Re: Canterbury Bankstown City Council Submission to the State Significant Development Application, SSD-83256463 – 150 The Boulevard and 34 Dudley Street, Punchbowl, Punchbowl, Homes NSW Affordable Housing Development

Attachment A - Summary of Additional Information, Amendments and Recommended Conditions of Consent Requested by Council

Attachment B - Detailed Comments

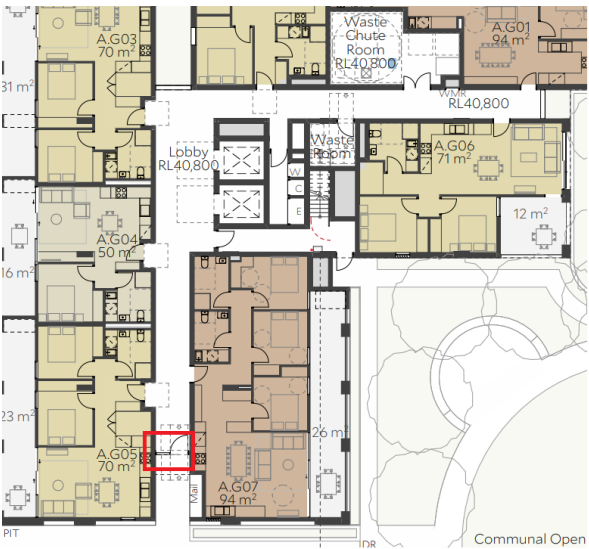
Category	Council Feedback
Engineering Services	Stormwater 1.1 The proposed design of the underground On-Site Detention (OSD) will not be supported with its current connection to the new inlet pit within Dudley Street, because proposed OSD storage will not be achieved as intended due to backwater effects, drowned orifice and dead storage. 1.2 The proposed design is intrusive requiring the installation of a new 375 Ø new concrete pipe (approximately 25m long along the kerb line within Dudley Street). The site enjoys a generous natural slope which provides an ideal platform for a less intrusive stormwater design following the natural slope, where stormwater can easily be discharged onto the kerb within The Boulevard without the need for a new street stormwater system along Dudley Street, this kind of design is reserved for difficult, restricted and flat site with hardly any slope, which is not the case for the subject site. <u>Recommendation:</u> It is strongly recommended that the stormwater drainage design should be prepared by an engineer with relevant hydraulic design experience. Basement car park 1.3 The location of structural column between spaces 17 & 18 and 19 & 20 do not comply with Figure 5.2 Design Envelope Around Parked Vehicles of AS2890.1 (as shown in below snippet).  1.4 The shared area next to dedicate space No. 31 is restricted with the structural column, this area shall be unobstructed for it to be a functional space (as shown in below snippet).

Category	Council Feedback
	 <u>Recommendation:</u> Revised plans to be submitted that address the matters raised in items 1.3 and 1.4 above.
Stormwater - Asset Systems & Planning	1.1 Stormwater – Easement – Council’s mapping records outlines the approximate location of an existing Council Street stormwater pipeline 525mm Ø which appears to traverse within the site frontage (as shown in below snippet). A service protection report shall be provided to accurately locate the stormwater pipe, a formal drainage easement will be required to be established and registered where the location of the pipe is indeed within the front setback of the site.

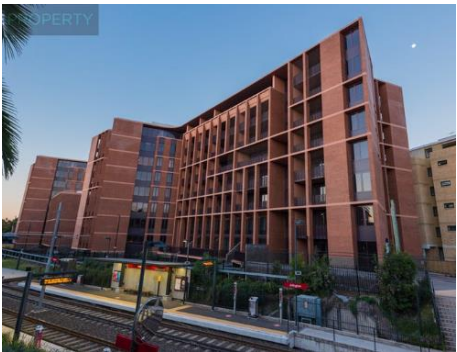
Category	Council Feedback
	residential amenity, and a more cohesive contribution to the evolving character of The Precinct. Key points are detailed below. 1.4 The ‘central spine’ between building A and B, at approximately 4.8 m wide and enclosed by eight-storey walls, is likely to feel constrained and overshadowed, offering limited sky views and wind protection. Given its’ role as a key pedestrian and communal circulation space, it should provide a stronger sense of openness and comfort at ground level. <u>Recommendation:</u> Increase the separation between building A and B to a minimum 6m, and/or introduce upper-level setbacks from level 5 onwards to improve daylight access, sky visibility, and overall human scale. Amenity 2.1 The proposed development does not comply with ADG’s minimum separation distances along the eastern boundary adjoining 149 The Boulevard. Several units (AG01- A701) have balconies located approximately 3.6 m from the boundary, while others (A407 - A707) have living room windows at around 6.3m. This proximity compromises the visual privacy of the development and the future development on the adjoining lot, which is expected to redevelop to a similar height under the Masterplan. <u>Recommendation:</u> The ADG separation distance be achieved as 6m to the boundary for the first 4 stories, and 9m for levels above for habitable rooms. Alternatively, balconies on these units be removed, with non-habitable windows provided where 3m and 4.5m setbacks apply. 2.2 More than 15% of the apartments don’t achieve any solar access on winter solstice between 9am to 3pm, primarily affecting the western facing apartments. Given the project’s Design Excellence requirements, higher levels of solar performance are expected to ensure quality internal amenity. <u>Recommendation:</u> The layout is reconfigured to increase solar access by reducing the number of single-aspect apartments per core and introducing additional dual-aspect or corner units where possible. 2.3 There is an opportunity for Building A to establish direct pedestrian access from The Boulevard, adjacent to the public open space, to strengthen its connection with the street and create a pleasant, welcoming secondary access point. <u>Recommendation:</u> Review the internal layout and consider making adjustments to maintain adequate levels of visual privacy for ground-floor apartments and to clearly delineate the public and private realms. 2.4 The western pedestrian access from The Boulevard provides a direct connection from the street to the communal open space, which is highly supported. However, its angled orientation and proximity to the driveway limit visibility and pedestrian legibility.

Category	Council Feedback
	<u>Recommendation:</u> The proposal should reconfigure this pathway to run parallel to the adjacent vehicular driveway, ensuring clear sightlines and a stronger visual connection with the street. 2.5 Several apartments (AG01,AG03, A101, A104, A201, A204, A301, A304, A401, A404, A501, A504, A601, A604, A701 and A704) include extended balcony portions of very narrow width that can barely accommodate seating or a small table, limiting their usability and functionality. In addition, some adjoining rooms have no access to these balconies, further limiting their accessibility and genuine usability. <u>Recommendation:</u> The proposal should adjust balcony widths and access points to enhance the overall quality and amenity of private open spaces. 2.6 Unit B104 presents an opportunity to strengthen façade alignment and improve private open-space amenity by extending its balcony southwards to align with the building's southern edge. <u>Recommendation:</u> This adjustment would create a more functional and proportionate outdoor area, enhance daylight penetration, and contribute to a more consistent façade composition along the southern elevation. 2.7 The proposed waste management arrangements require the bins from Building A to be transferred through the main residential corridor at ground level to the collection room in Building B, creating potential conflicts with resident circulation and compromising the amenity of the ground floor spaces on the collection day. <u>Recommendation:</u> The proposal should nominate an alternative route, preferably via the basement levels or a dedicated service corridor at the rear, to avoid conflicts and ensure an adequate level of amenity. Façade design and articulation 3.1 The façades of Building A, along The Boulevard and Dudley Street exhibit excessive vertical and horizontal modulation, resulting in a visually busy yet monotonous expression. The composition lacks variety, material richness, and hierarchy, giving the façade a repetitive, formal appearance. <u>Recommendation:</u> There is an opportunity to simplify the articulation and introduce greater material diversity, depth, and contrast to create visual interest and a more distinctive architectural character that better reflects the desired street identity. These refinements should align with the emerging street-wall height and desired future character (refer to 1.3), ensuring that the lower levels present a human-scale rhythm, and the upper levels are visually lightened through recesses or tonal contrast Refer to the images below for further reference.
